Date:	27/09/02	Chairman:	Horst Faas
Doc.-No.:	HP-2-ASED-MN-0182	Secretary:	Horst Faas
Meeting place:	ASED, Friedrichshafen	Close of Meeting:	Close of Meeting
Date/Time:	27/09/02 / 09h00		
Agenda dated:	See attached

Subject: Mech. Interface Meeting with Spire

Comments on SPIRE Configuration Drawings (Issue 16, dated 28/08/2002)

Source: HP-2-ASED-TN-049, Issue 1, Analysis Results

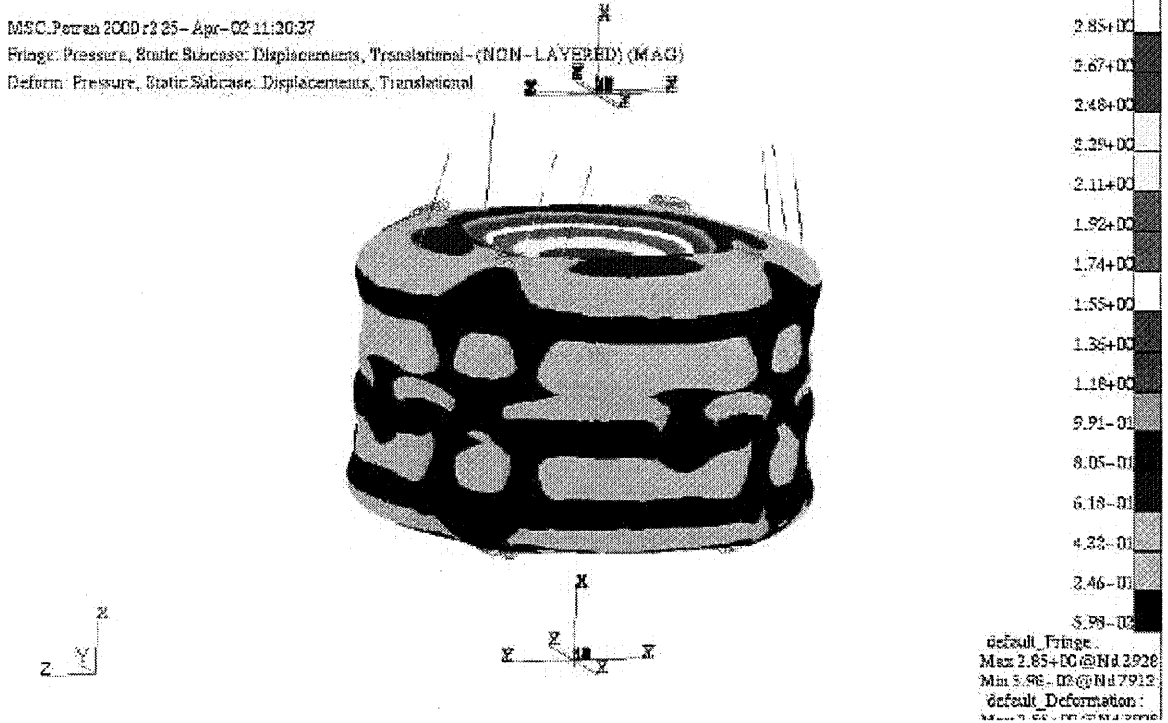
Analysis on System PDR Design Baseline,
Tank PDR next week

Therefore margin needed for Tank Design Evaluation

Component	Direction	Thermal Displacement	Vibration	Pressure of Tank ¹⁾
Links except PACS	axial	-0.15	+ - 1.1 mm	+0.6mm – 1.8 mm
	lateral	2 mm	+ - 1.7 mm	3 mm
PACS	axial	0.15	+ - 1.1 mm	-1.7 + 5.1 mm
	lateral	1.8 mm	+ - 1.7 mm	-2.8 to + 8 mm

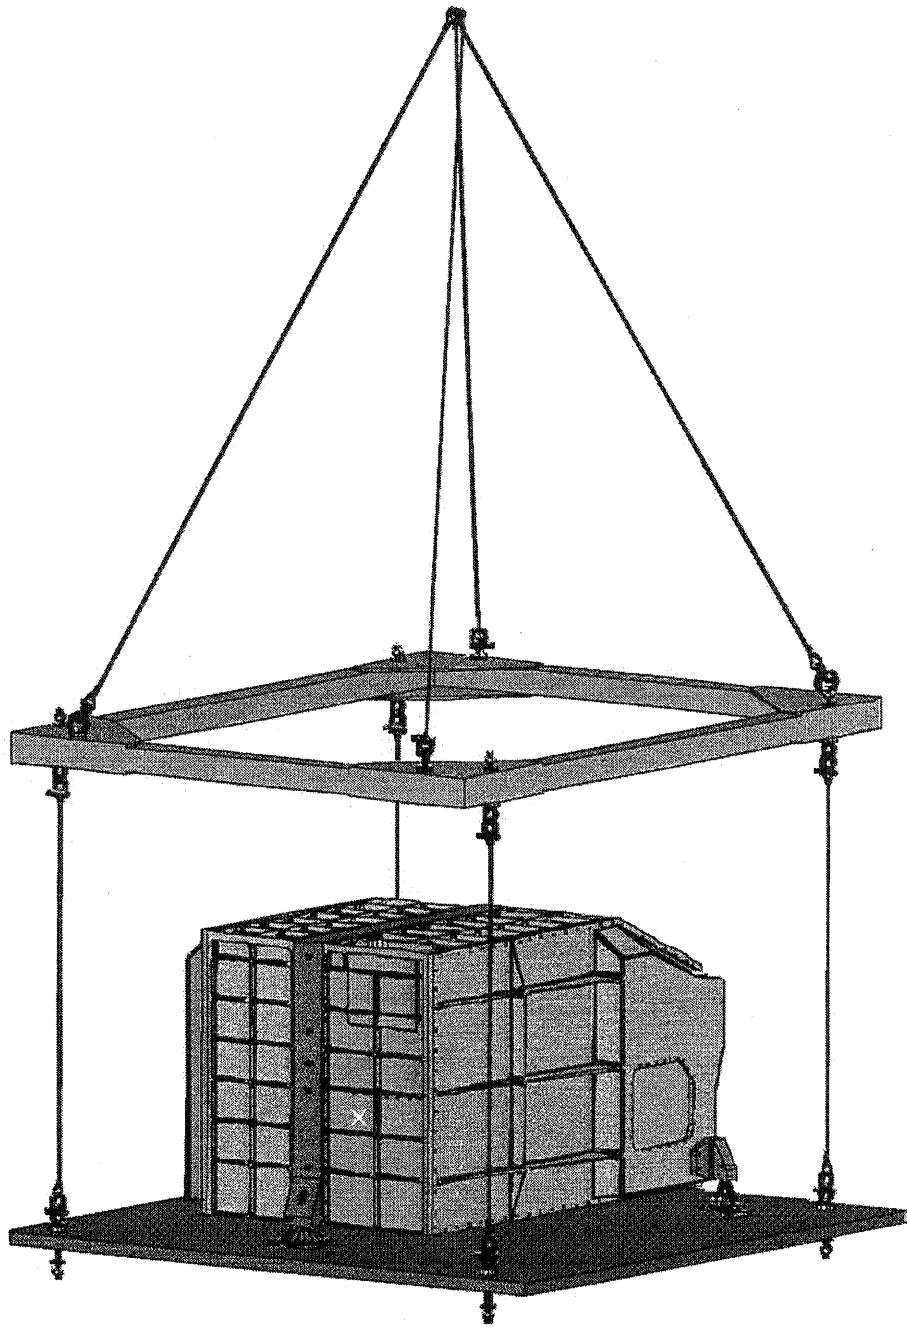
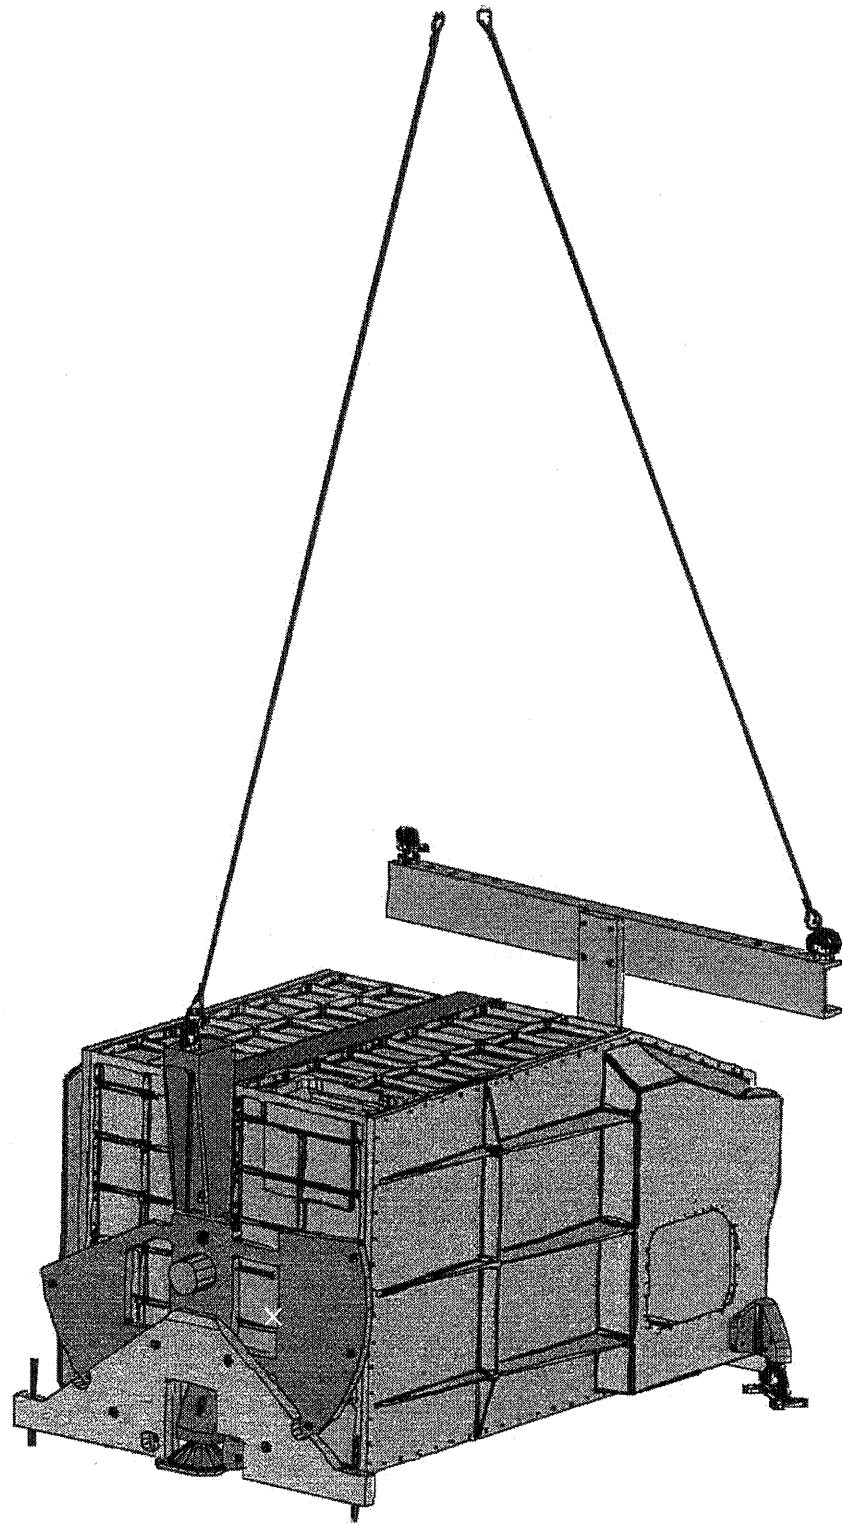
→ 10 mm are an envelope for the level 0 I/F of the instruments

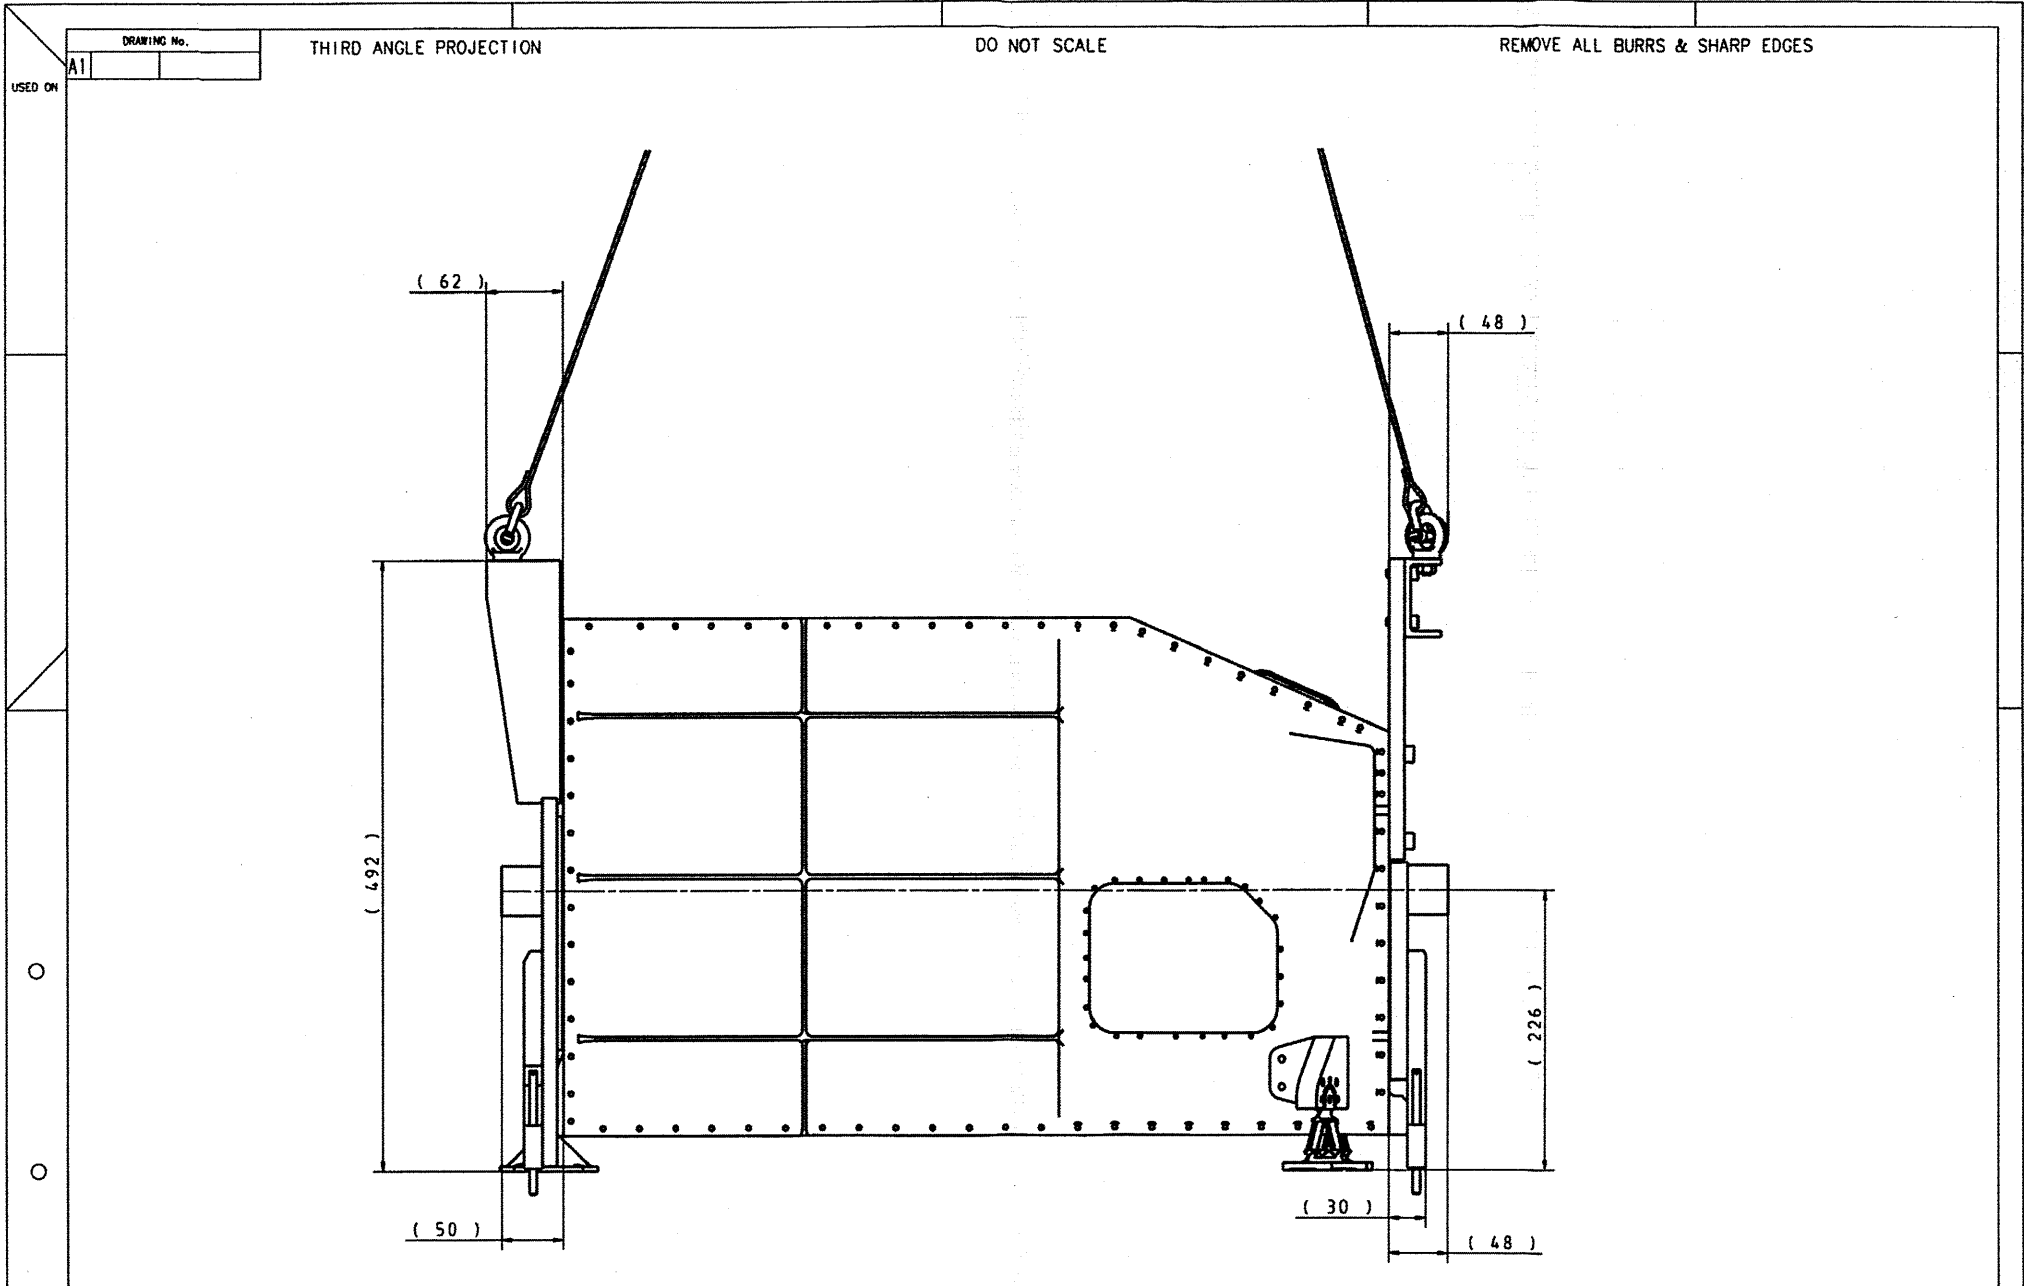
1. Sheet 1 of 7 and other sheets: Cryostat hole is 288mm. Please update.
2. Sheet 1 of 7: Comment Alternative attachment points: Level-1 strap is connected to ventline, not to Optical Bench. Update.

3. Sheet 1 of 7: Optical Reference Cube changed from 25x25x25mm to 31x31x31mm. Change to be discussed in framework of thermal and straylight impact of alignment cube, if not dismantled.

4. Sheet 1 of 7: Photometer and Spectrometer BDA feedthroughs to be added
5. Sheet 1 of 7: Instrument shield not up-to-date, could be replaced by update
